**AMENDMENT NO. 1 MARCH 2026**

**IS 18809 : 2024 WEAR AND ABRASION RESISTANT STEEL  
SHEET AND PLATES — SPECIFICATION**

FIG 1. LOCATION FOR CORE HARDNESS MEASUREMENT

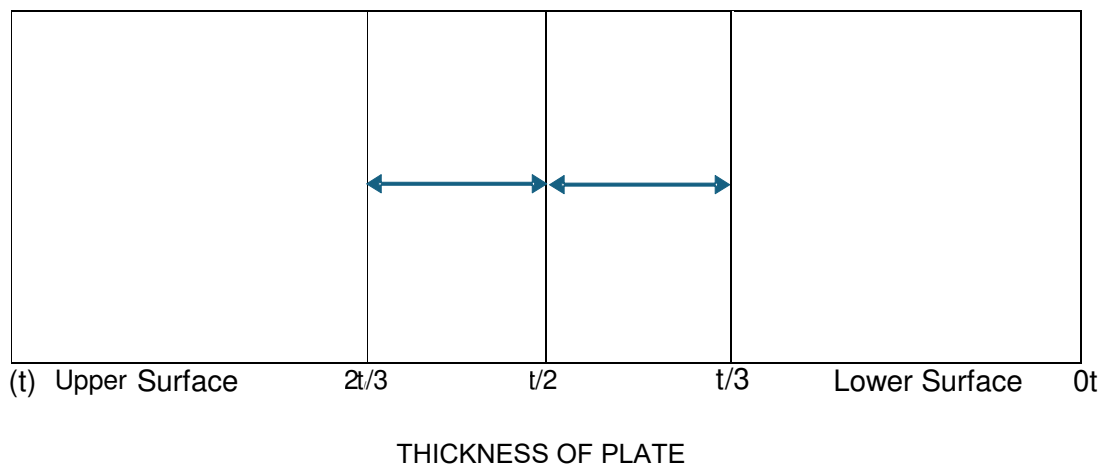
(Page 6) — Insert the following new annex:

The Core hardness is defined as the average through thickness hardness in the Plate in  $1/6^{\text{th}}$  the thickness on either side of the center point of plate thickness, that is  $1/3^{\text{rd}}$  the inner thickness of the plate. The hardness is measured by Vickers hardness testing (*see* IS 1501 (Part 1)) equipment at least 3 different spots – at  $1/3$ ,  $1/2$  and  $2/3$  thickness along the thickness of the plate, as per the figure given below:
